# **ADDENDUM NO. 1**

# **NCSU** Renovations to the Don Ellis Building

SCO ID# 19-21547 NCSU ID# 201920037 SFK PROJECT NO. 1368-20

December 5, 2023

**A-700**

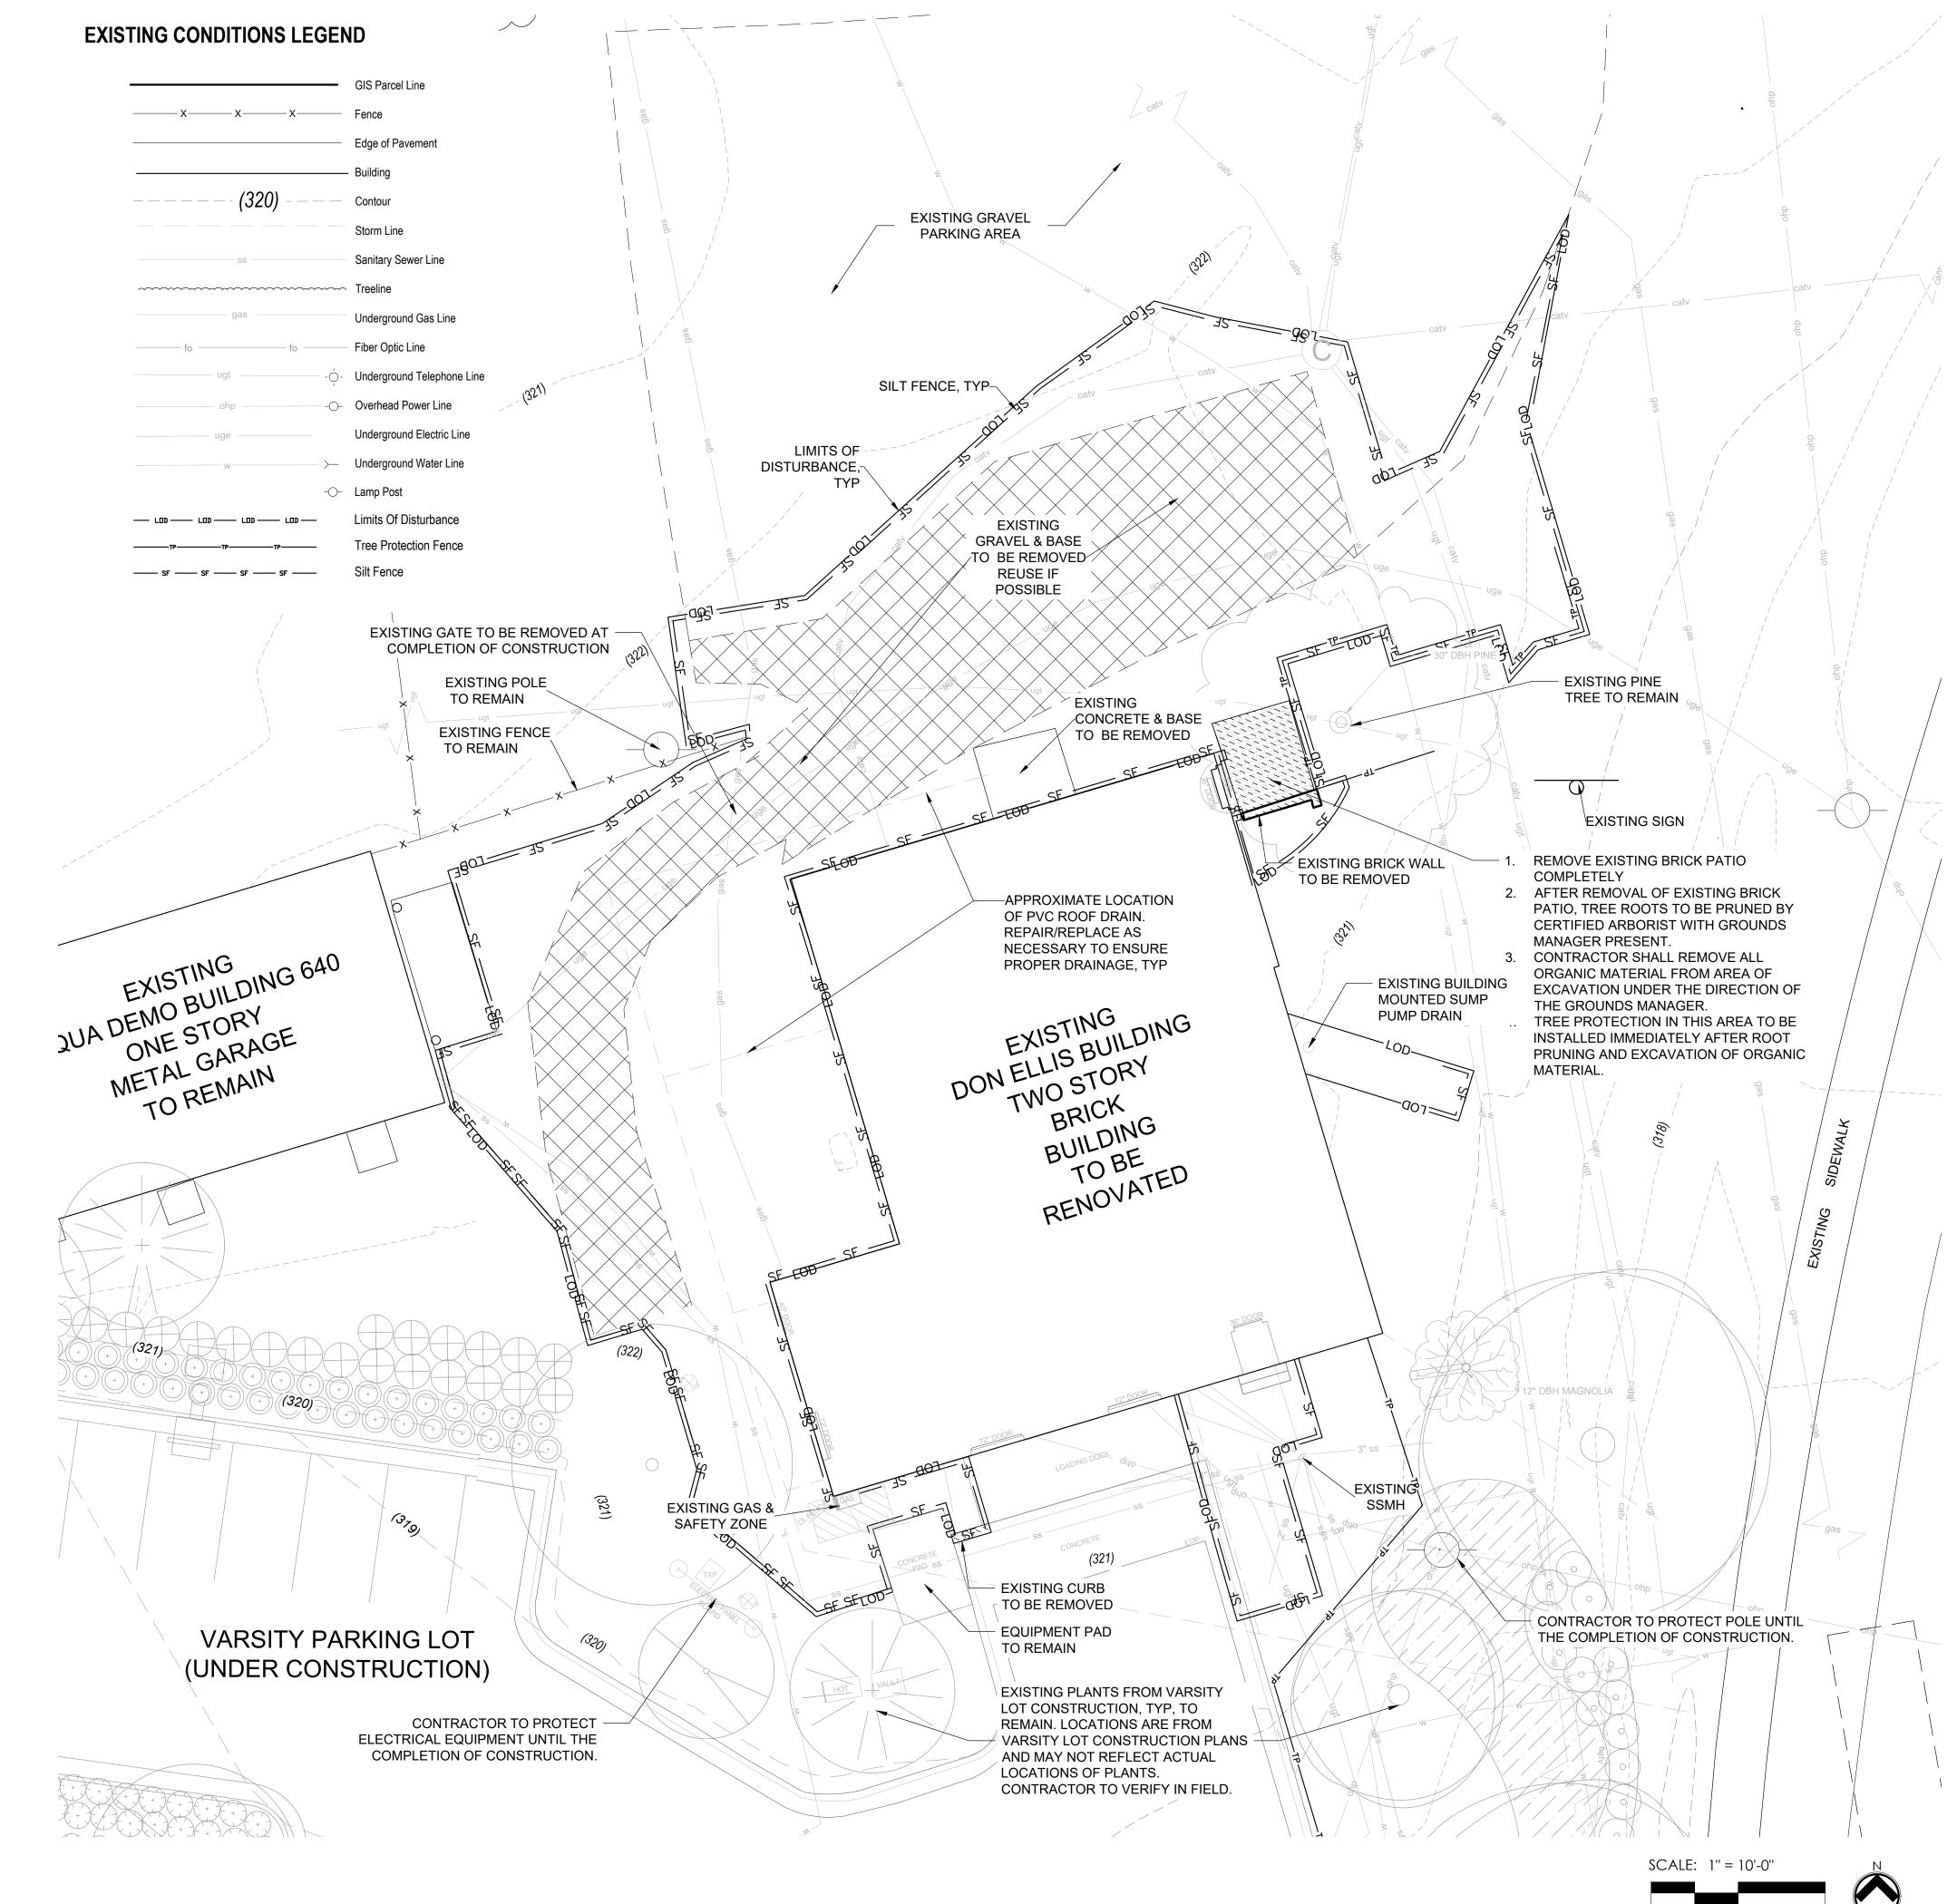
- a. Side elevation at mechanical electrical room provided
- 8. Sheet A-700 : *Replace* with sheet A-700 attached
  - a. Accent walls indicated
- 9. Sheet L-100; *Replace* with sheet L-100 attached.

L-100

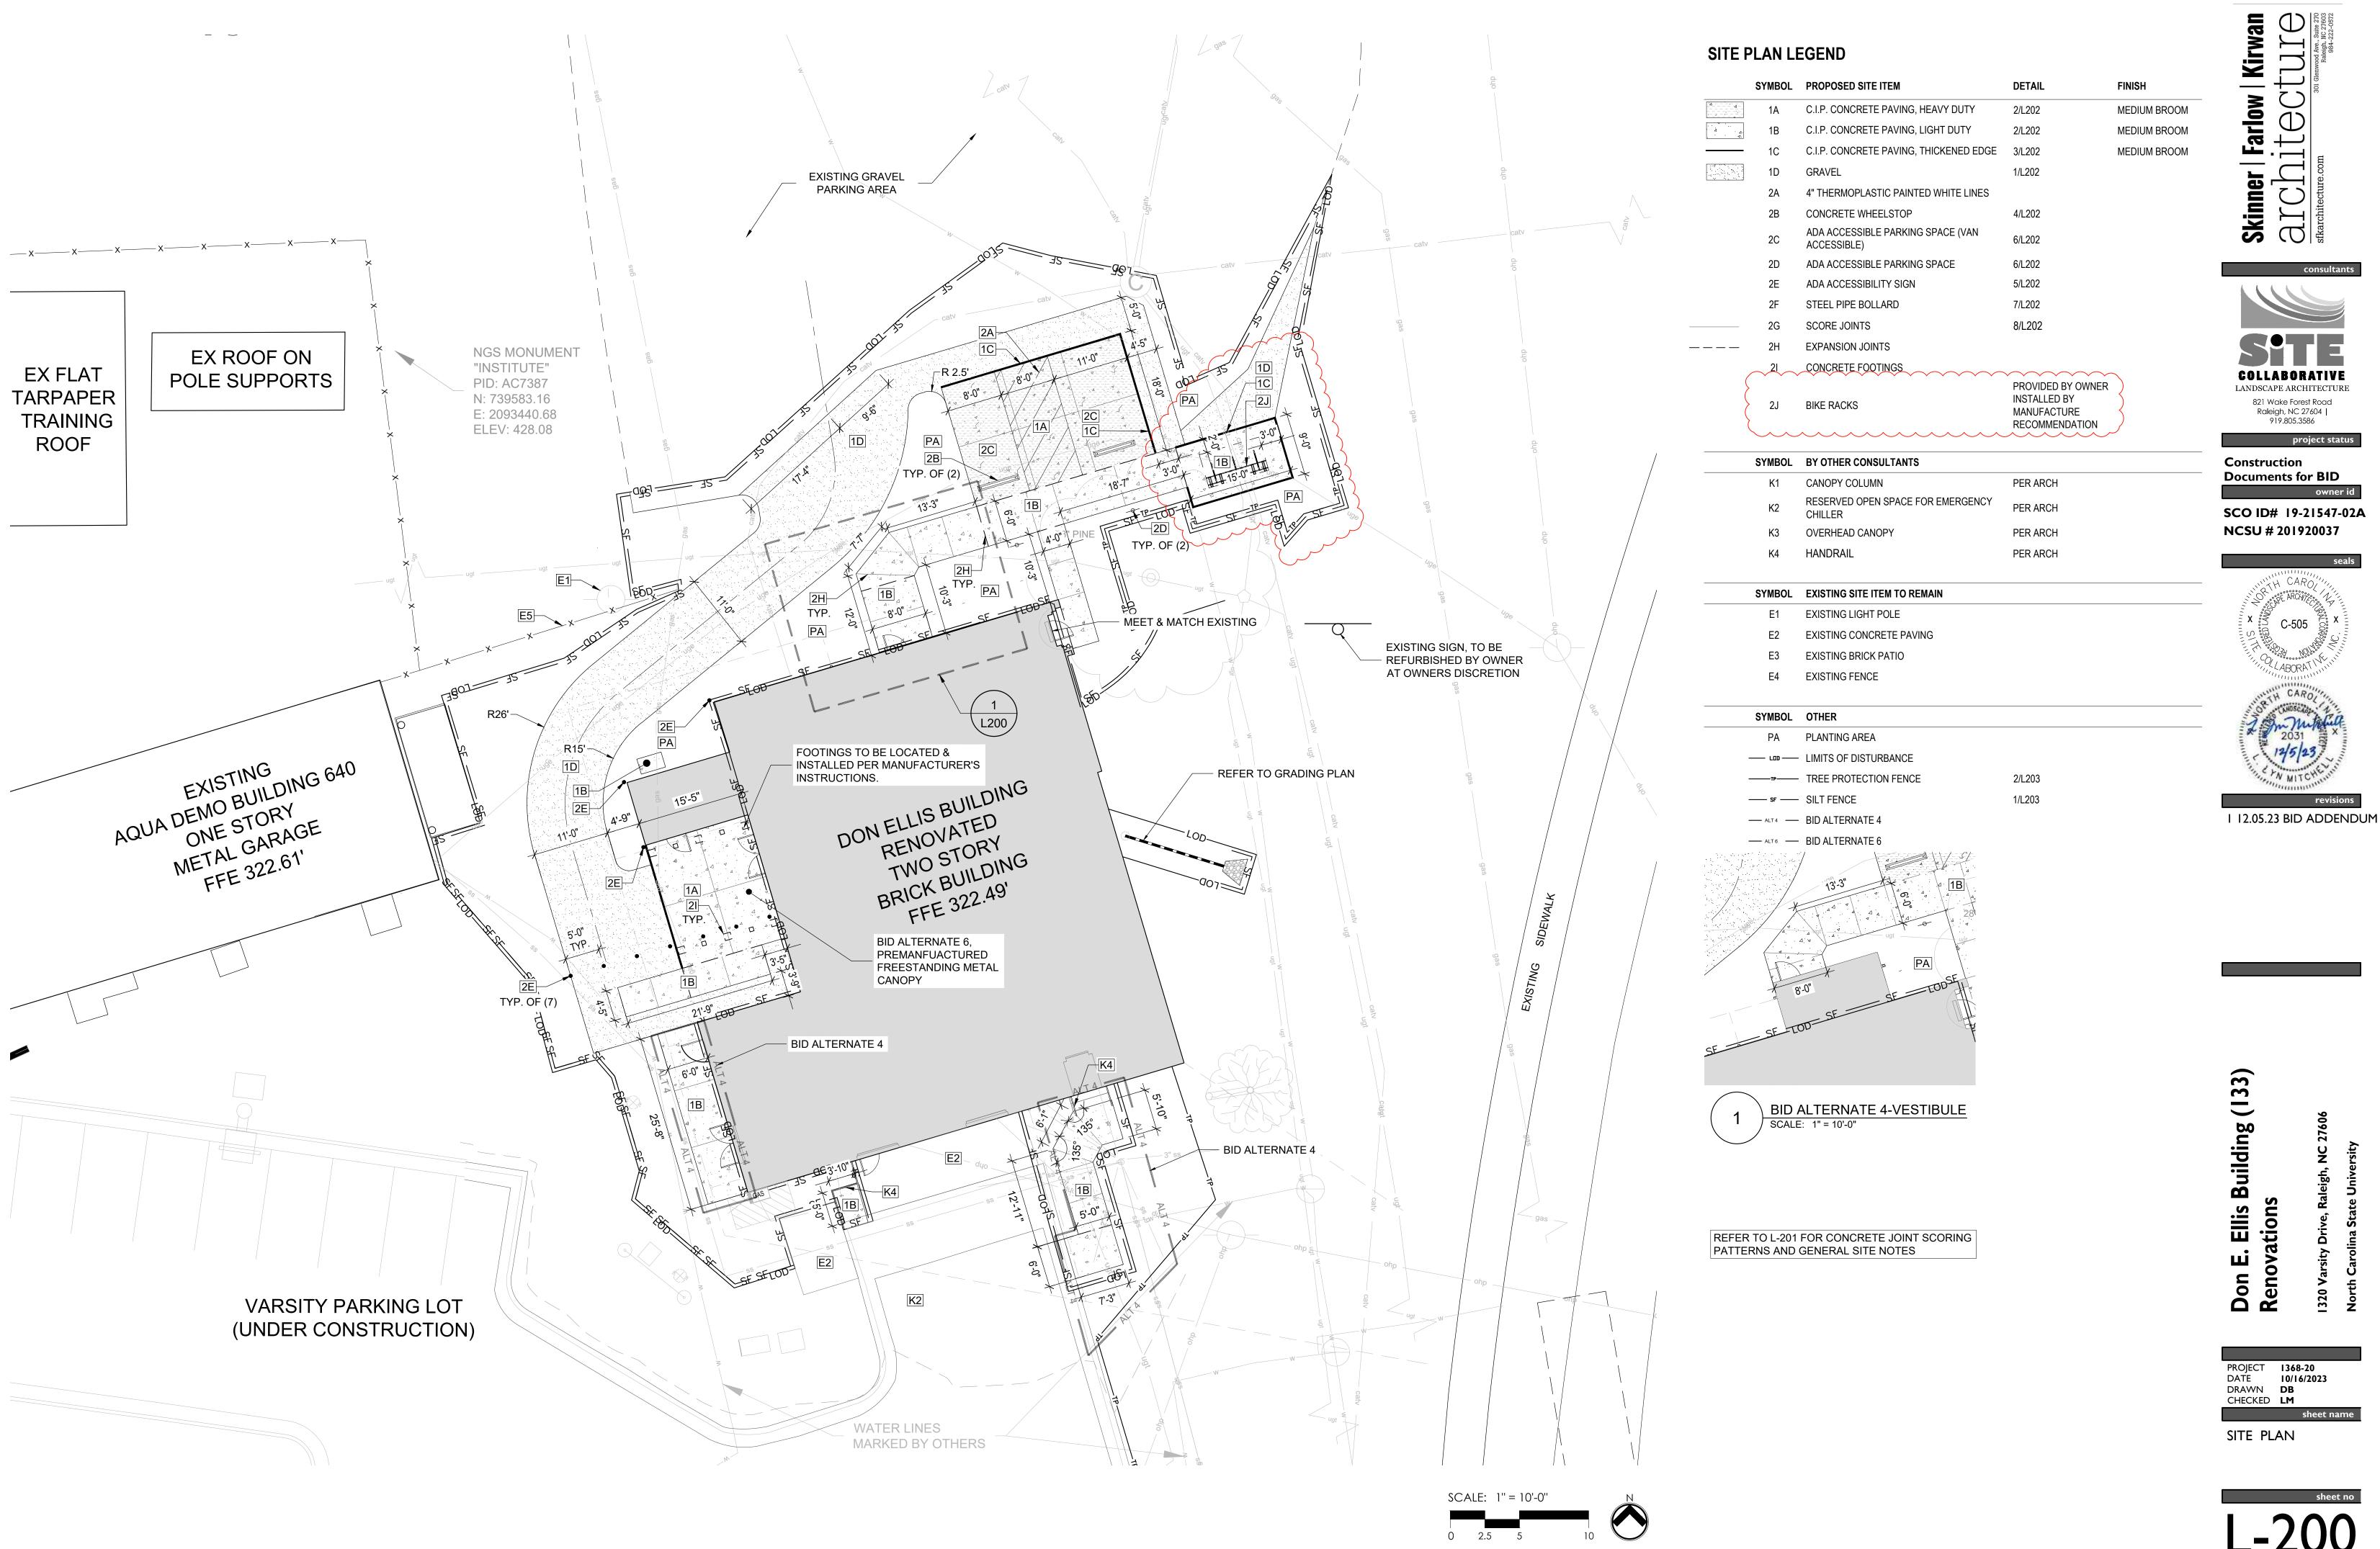
- a. Notes revised under property data
- 10. Sheet L-200: *Replace* with sheet L-200 attached.
  - a. Bike racks added to plans with notes
- 11. Sheet L-300: **Replace** with sheet L-300 attached

- CURRENT OWNER: NORTH CAROLINA STATE UNIVERSITY
- 2. SITE ADDRESS: 1350 VARSITY DRIVE, RALEIGH, NC 27606
- 3. PIN: 794507874
- 4. DEED REFERENCE: DB 125 PG145
- 5. TOTAL SITE AREA: APPROXIMATELY 12.73 AC (SURVEYED)
- 6. AREA OF DISTURBANCE: 7,387 SF
